Attachment A

Revise the Technical Specification pages as follows:

In February 1986 a Technical Specification change was approved that allowed operation of a mini-purge system at Ginna. The old 48 inch containment purge system was sealed with blank flanges that can only be removed at cold or refueling shutdown. The 48 inch system, now called shutdown purge, is only operated during cold or refueling shutdown and exhausts into the containment vent. The new mini-purge system is designed to pass through charcoal and HEPA filters and to exhaust into the plant vent. Since the two systems will exhaust into different places Technical Specification Table 3.5-6 item 3 must be changed to cover operation of the mini-purge system. Details of the Technical Specification changes are presented on Table 1. A functional diagram of the radiation monitors is presented on Figure 1.

Detailed Technical Specification Changes

FIGURE 1

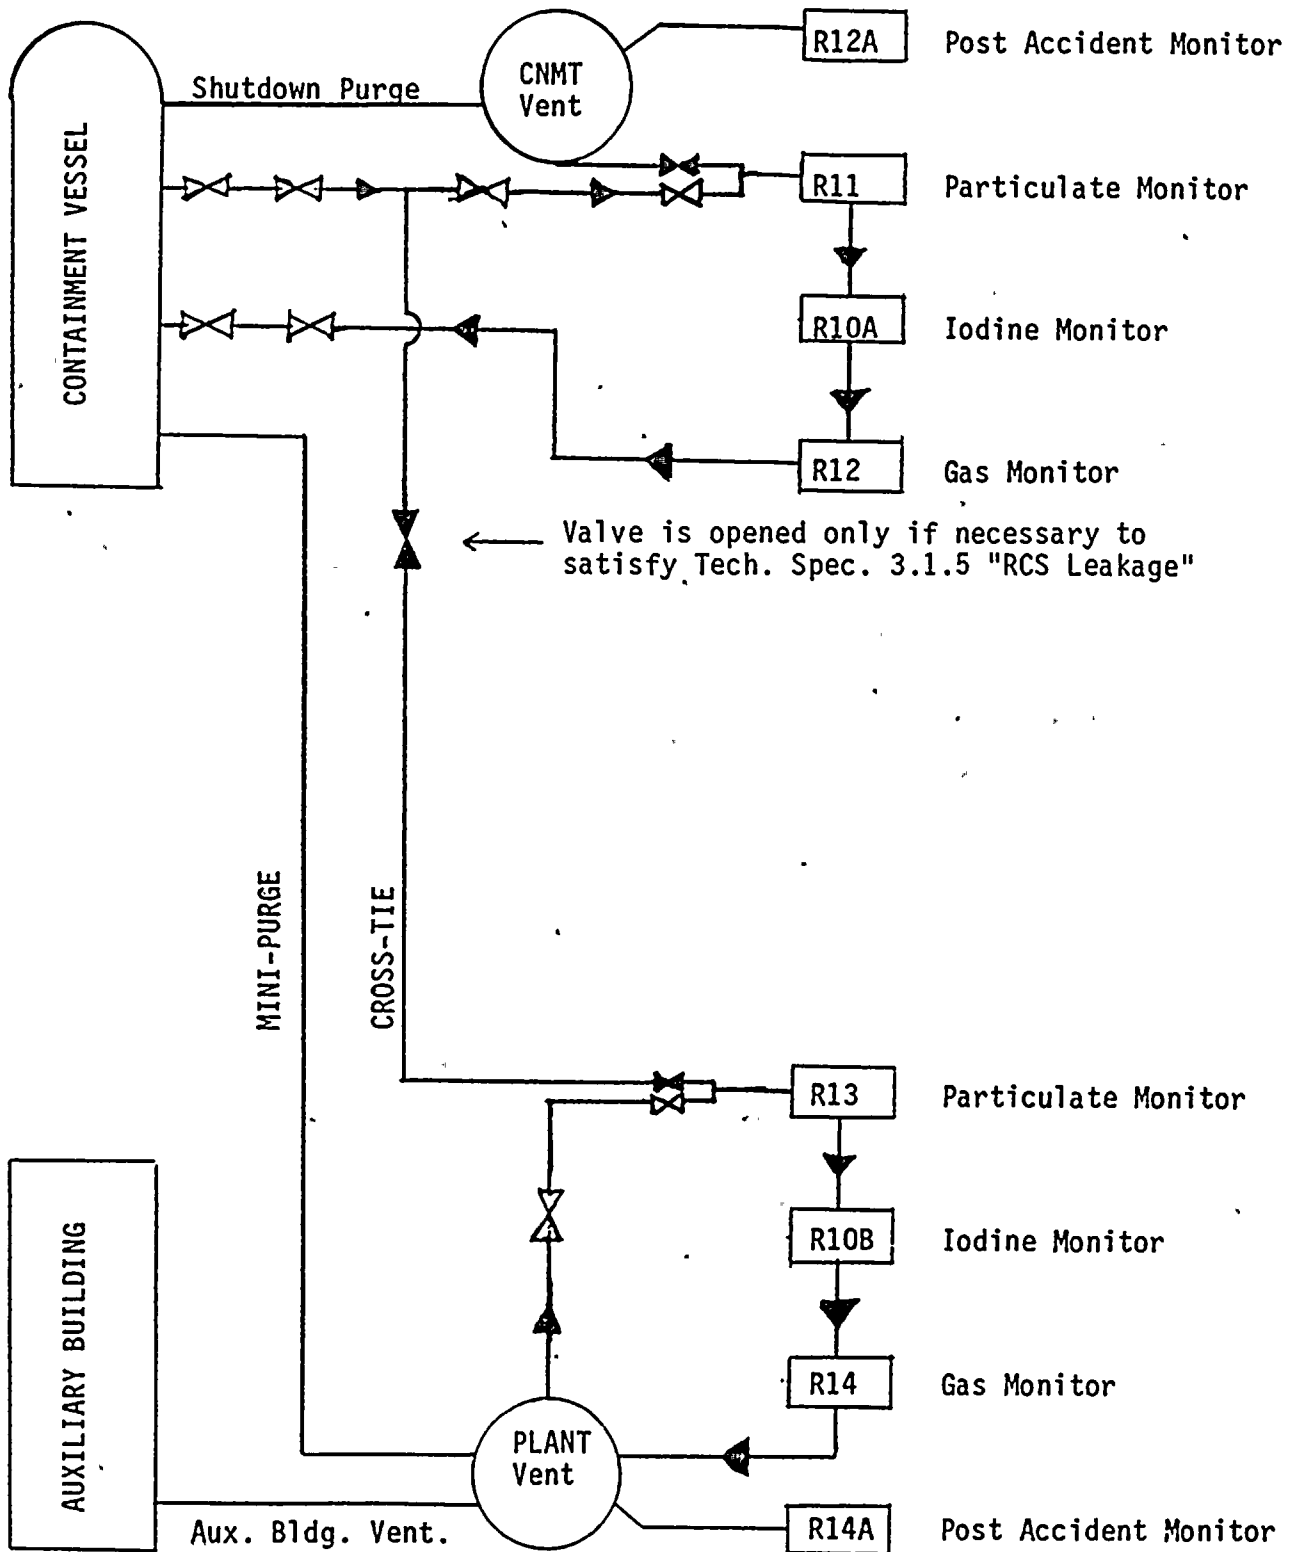
Monitors R-11 and R-12 generate isolation signals for mini-purge and shutdown purge. R-11 and R-12 can monitor either containment or the containment vent. When monitoring the containment, both R-11 and R-12 are sensitive to increases in reactor coolant leakage. Because the mini-purge discharges to the plant vent, R-11 or R-12 is aligned to monitor containment during mini-purge operation to ensure an isolation signal is generated if necessary to limit releases below 10CFR20. Should the channel being used to monitor containment become inoperable (R11 or R12) mini-purge should be terminated within 1 hour. The 1 hour was chosen to be consistent with the generally accepted time for prompt action.

The following monitors are required for mini-purge operation: R-12 or R-11 provide mini-purge isolation if high concentrations of radioactivity are detected inside containment. Noble gas monitor R-12 and particulate monitor R-11 generate an isolation signal when their setpoint is exceeded. Iodine sampler R-10A generates an alarm when its setpoint is exceeded but does not generate an isolation signal. R-14, R-13, R-10B and R-14A will provide an equivalent level of protection for mini-purge releases as currently exists for plant ventilation releases.

Monitor R-12A is no longer allowed to be substituted for R-10A during mini-purge operation because R-12A only monitors the containment vent. Since mini-purge is connected to the plant vent, R-12A would not be monitoring mini-purge and therefore is not an acceptable substitute.
